**TOWN OF MILTON DEVELOPMENT REVIEW BOARD**  
**PUBLIC NOTICE OF AGENDA**  
**Regular Meeting of Thursday, February 26, 2015 at 7:00 p.m.**

# STAFF REPORT

## SITE PLAN and CONDITIONAL USE

### 297 McMullen Road

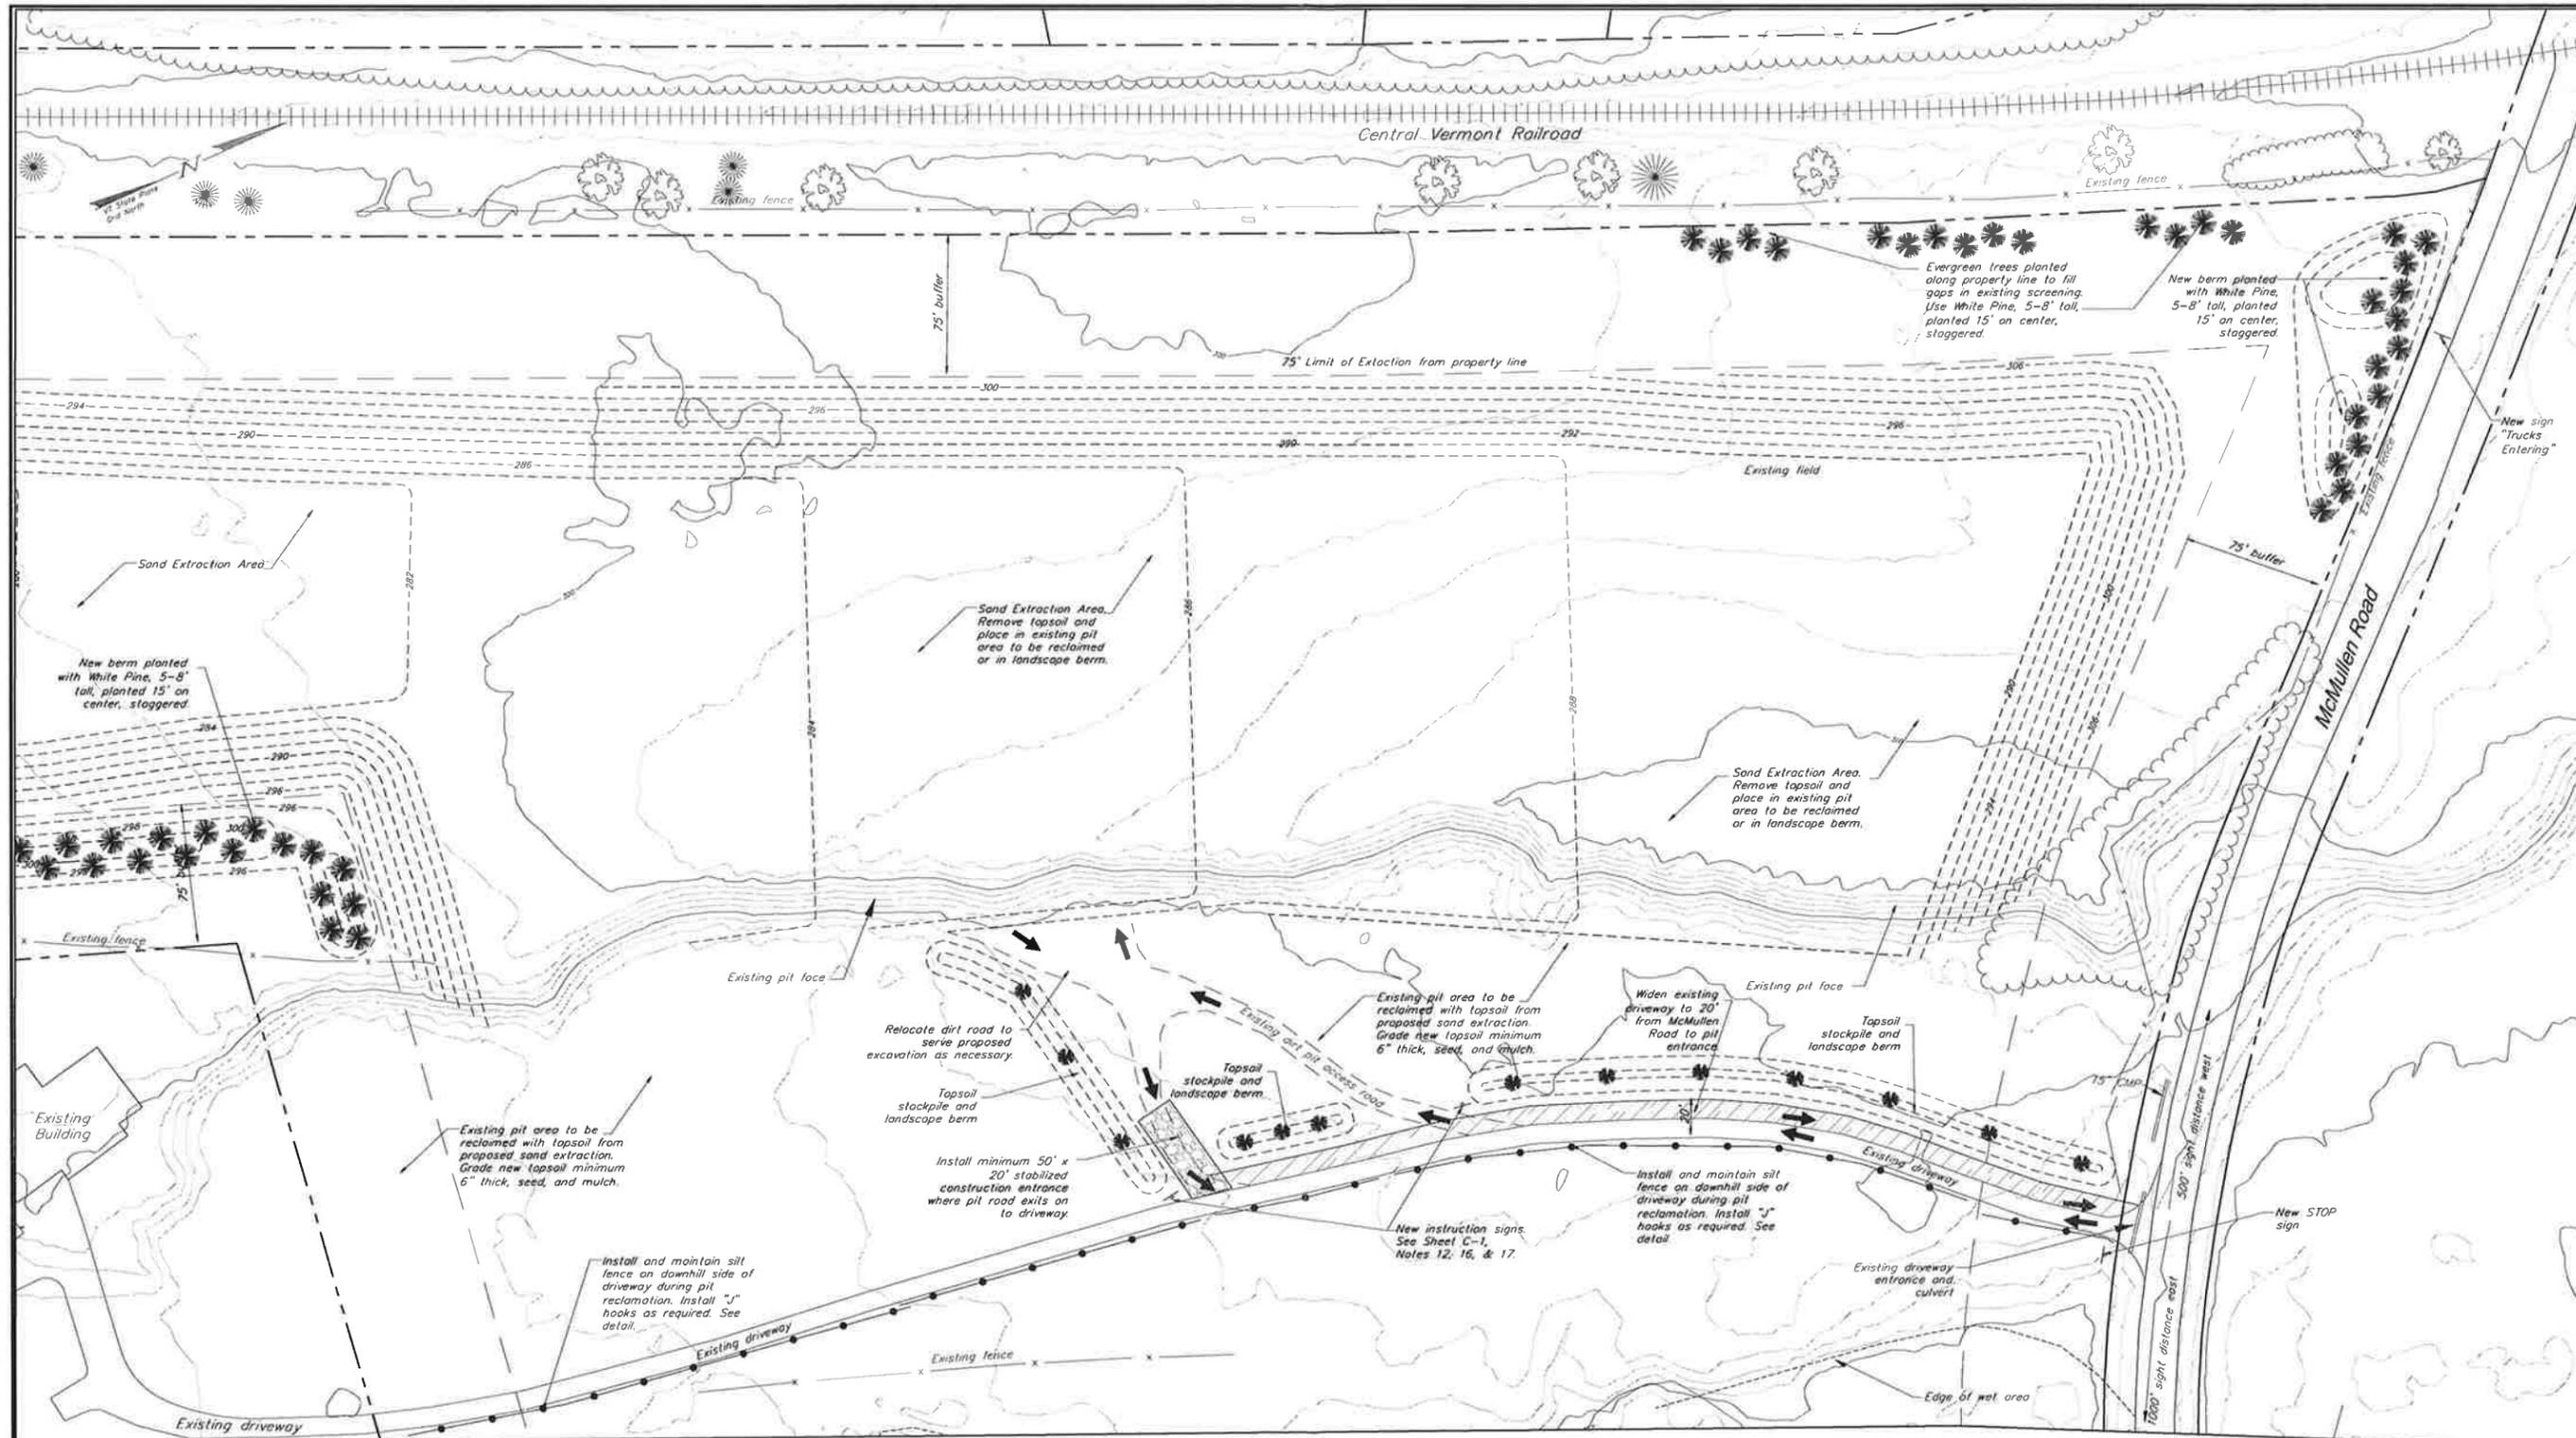
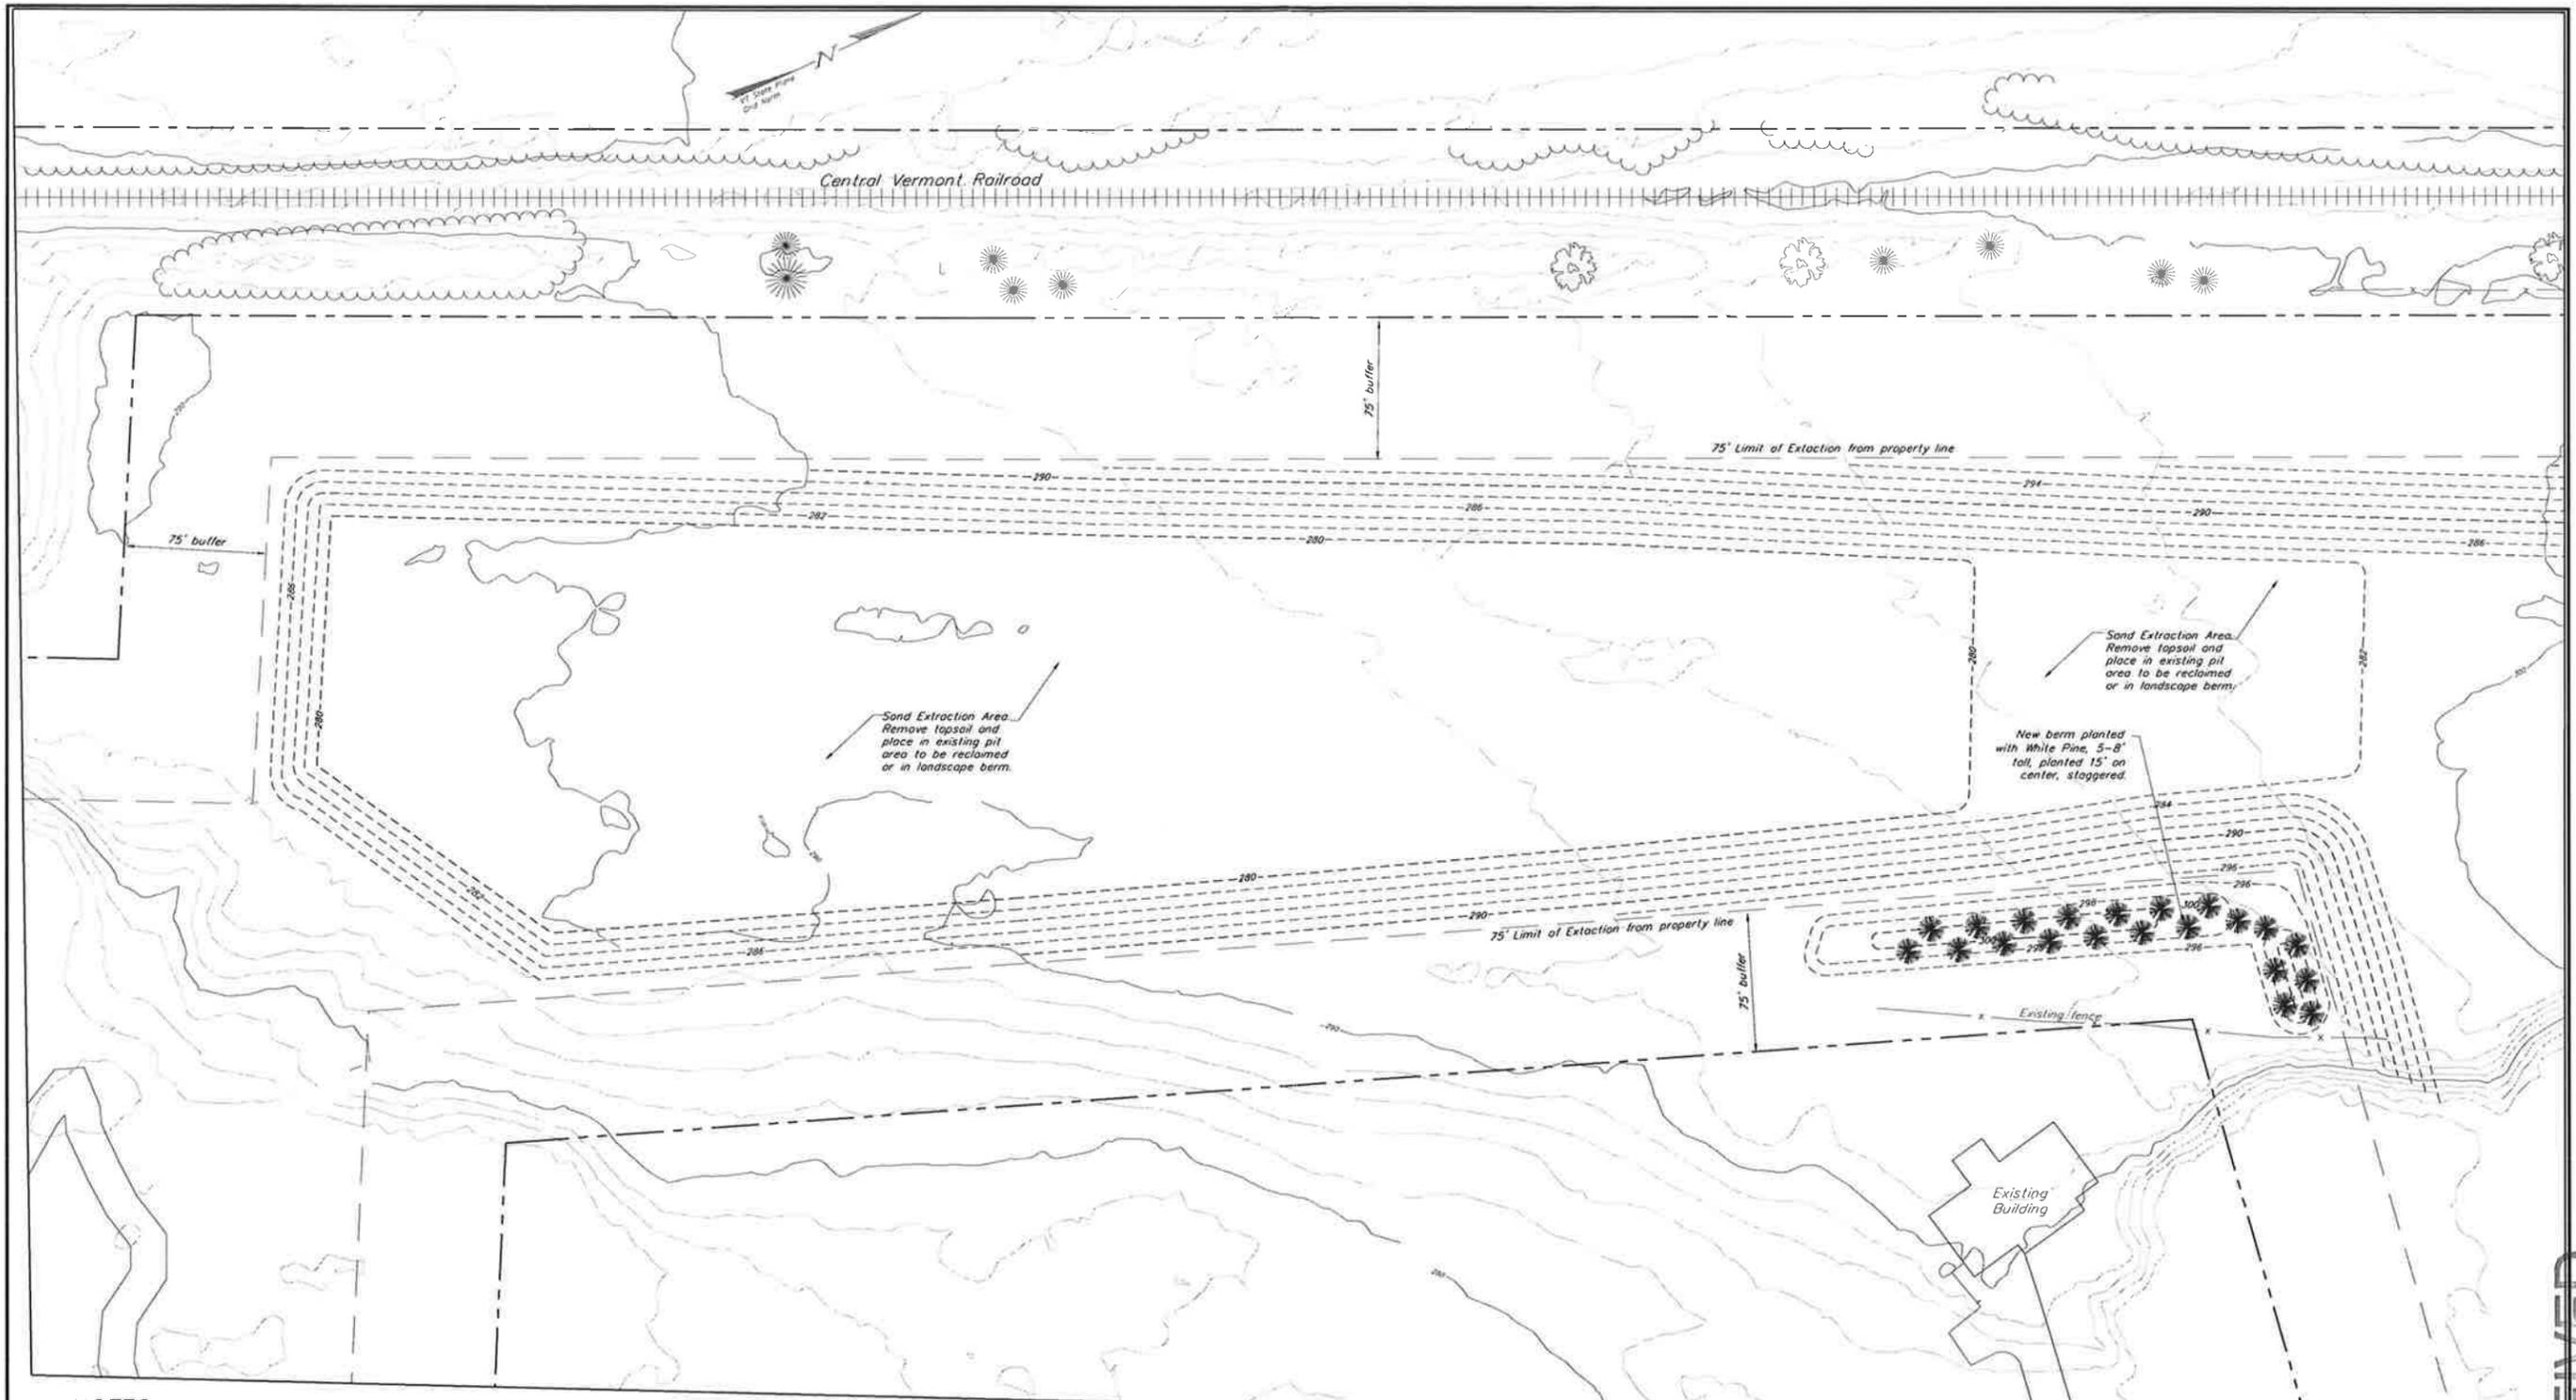
The plan includes no fencing. The written plan references an entrance gate but no gate is shown on the site plans. The plan includes landscaping. The plan includes dust control measures. The plan does not address noise.

**Basic Plan Information:** ZR803.1 not met, because adjoining land owners are not labeled.

**Proposed Improvements:** ZR803.5 is not met, because the site does not show the location of a proposed trailer structure.

25. The final site plans shall show the gates included in the written excavation plan, and the

28. The final plans shall include all site plan application requirements that are not met below, per ZR803.

**SHEET NUMBER**  
**C-4**  
SHEET 5 OF 9

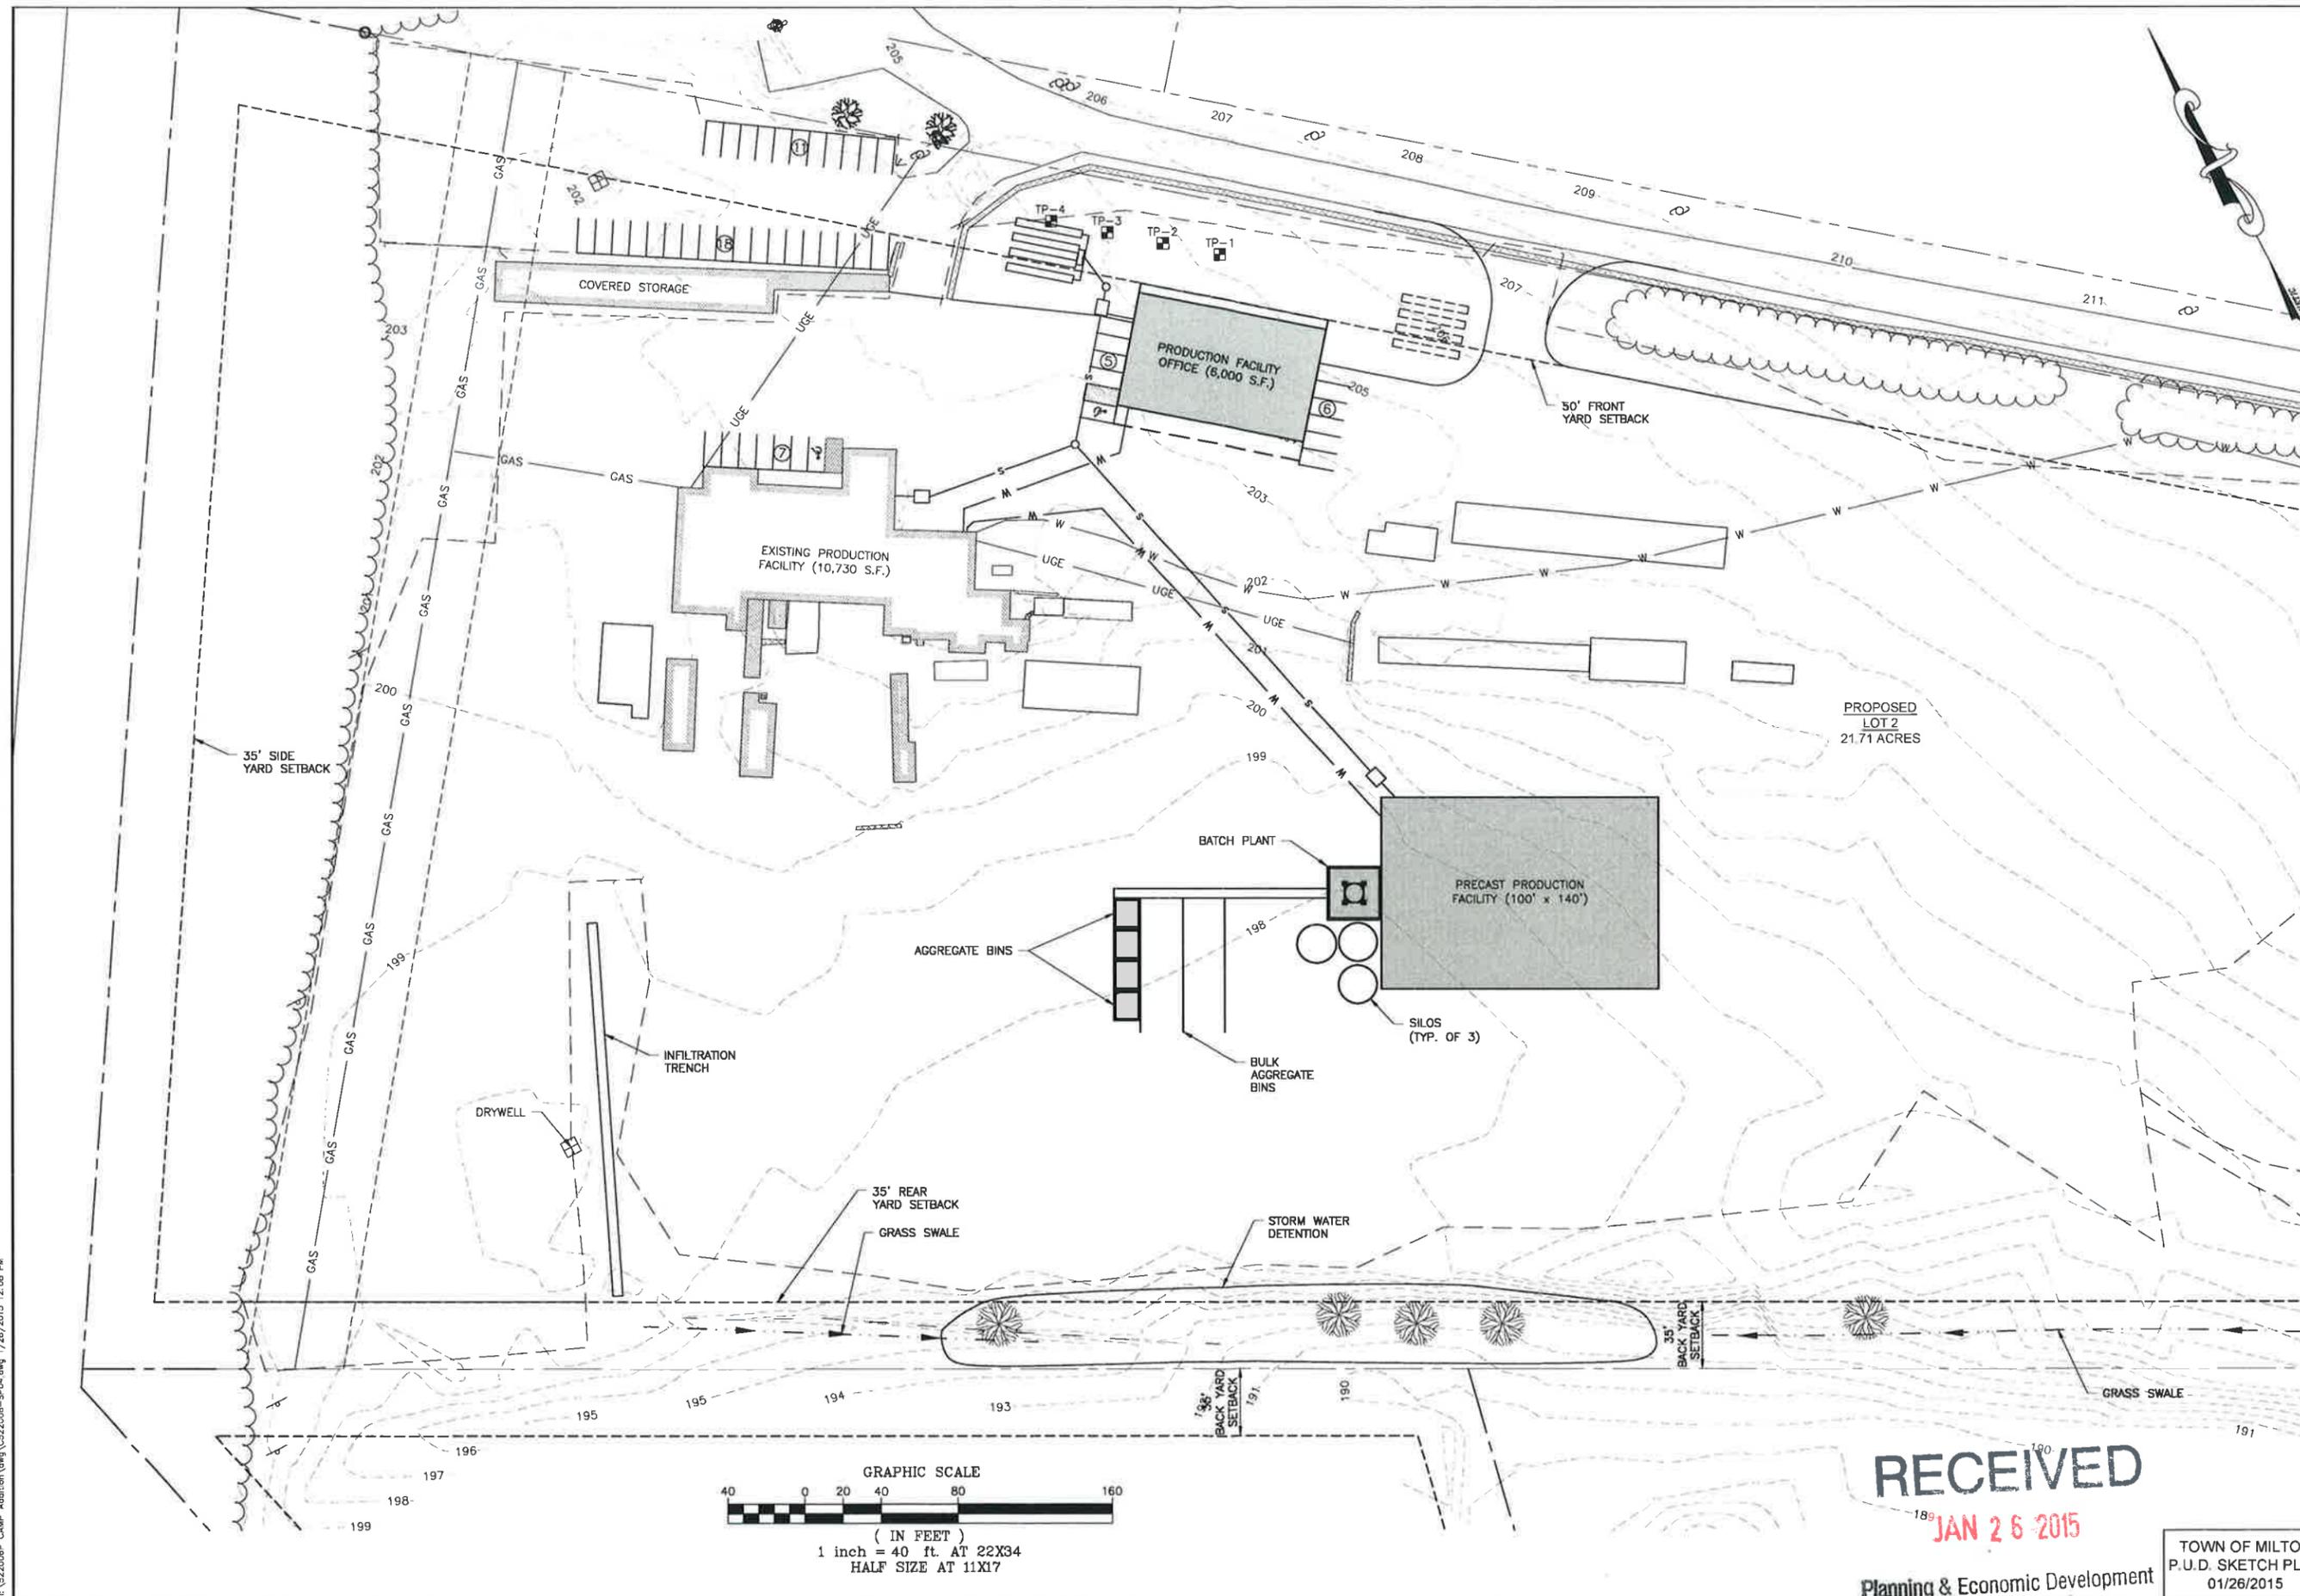
- The plans show (C-2) exiting from the east lane and entering from the west. This does not conform to the Town of Milton Public Works Specifications, Drawing #7, Commercial Drive Highway Access. Is there a reason for this?

- The plans shall show the commercial drive highway access radius per PWS Dwg. #7.
  - A trip counter shall be required. The approximate location shall be shown on the plans.

- The new highway access onto Precast Road shall conform to the PWS Dwg. #7 Commercial Drive Highway Access.
